SHANDON-SAN JUAN WATER DISTRICT SHANDON-SAN JUAN GSA

RE: Approved Determination of the Revised Groundwater Sustainability Plan Submitted for the Salinas Valley – Paso Robles Area Subbasin

Exhibit A: Groundwater Sustainability Plan Assessment Staff Report – Salinas Valley – Paso Robles Area Subbasin (June 20, 2023)

State of California
Department of Water Resources
Sustainable Groundwater Management Program
Groundwater Sustainability Plan Assessment
Staff Report

Figure 1: Locations of interconnection between groundwater and surface water.

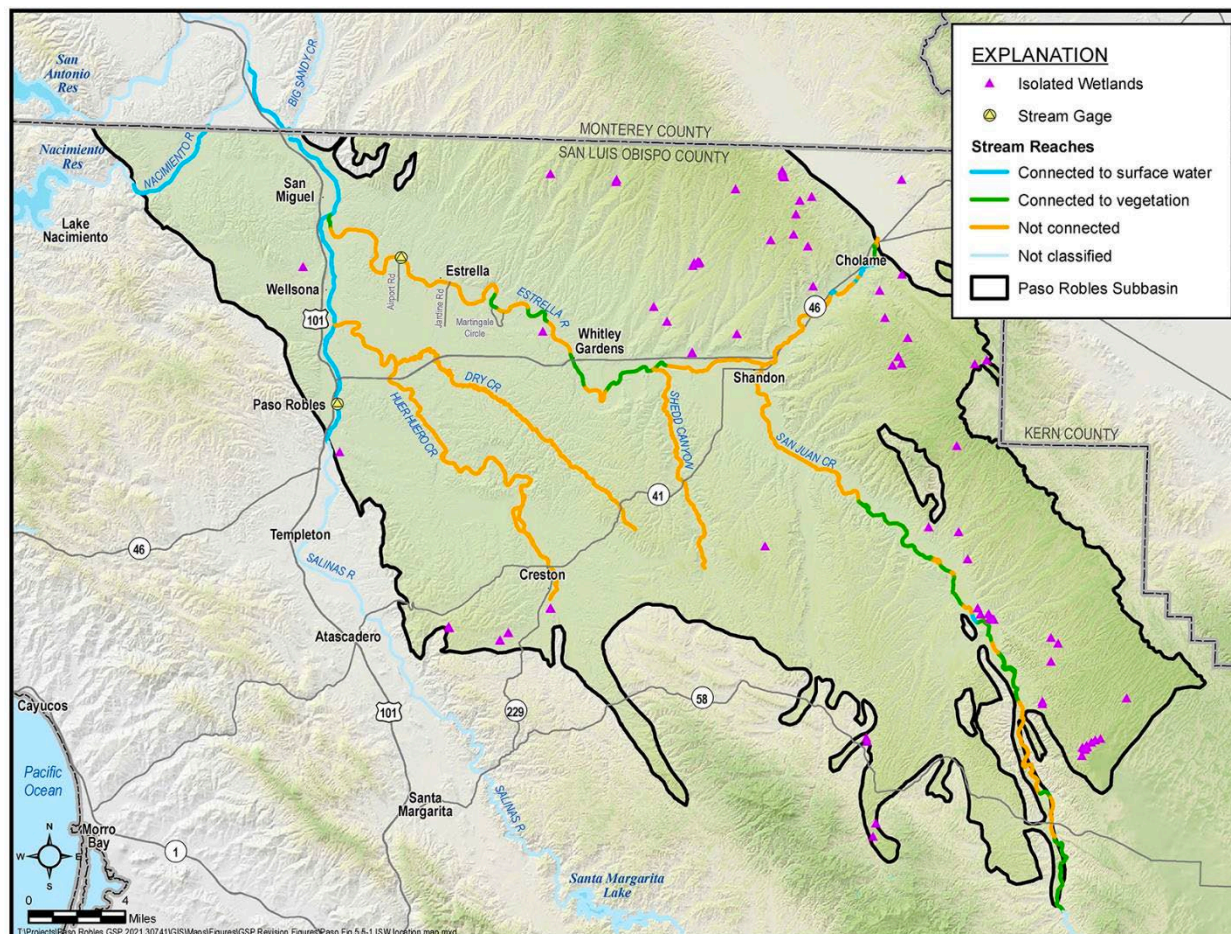
Staff consider the revised Plan to be generally improved but still missing information that should be included to improve clarity and completeness in addressing the GSP Regulations and facilitate staff evaluations of GSP and subsequent periodic evaluations. The Plan notes that pumping from the Alluvial Aquifer is “rare”, generally occurs to meet domestic and limited livestock water demands, and large-scale irrigation pumping does not typically occur.⁵¹ However, the GSP also states that the agricultural water use sector—which is the largest by volume⁵² with production wells located along the Salinas and Estrella Rivers⁵³—also pumps from the Alluvial Aquifer⁵⁴ without quantifying that volume. The GSP should provide specific volumetric quantities of estimated pumping that

occurs from the Alluvial Aquifer to detail the comparison of pumping from the Subbasin's two principal aquifers. Staff require this supporting information to assess whether the establishment of management criteria, which relies heavily on the claim that most groundwater pumping is from the Paso Robles Formation Aquifer, is a reasonable assumption. Additionally, while the GSP states analysis from *Methodology for Identifying Groundwater Dependent Ecosystems* indicates that groundwater pumping from the Paso Robles Formation Aquifer does not materially impact relevant groundwater dependent animals in Salinas River flows, the GSP does not discuss potential impacts of pumping from the Alluvial Aquifer on southern steelhead which migrate up and down the Salinas River in winter and spring. Department staff recommend the GSAs provide clear explanation of the usage of the Alluvial Aquifer and provide specific volumetric quantities of estimated pumping that occurs from the Alluvial Aquifer to detail the comparison of pumping from the Subbasin's two principal aquifers. (see [Recommend Corrective Action 4a](#)).
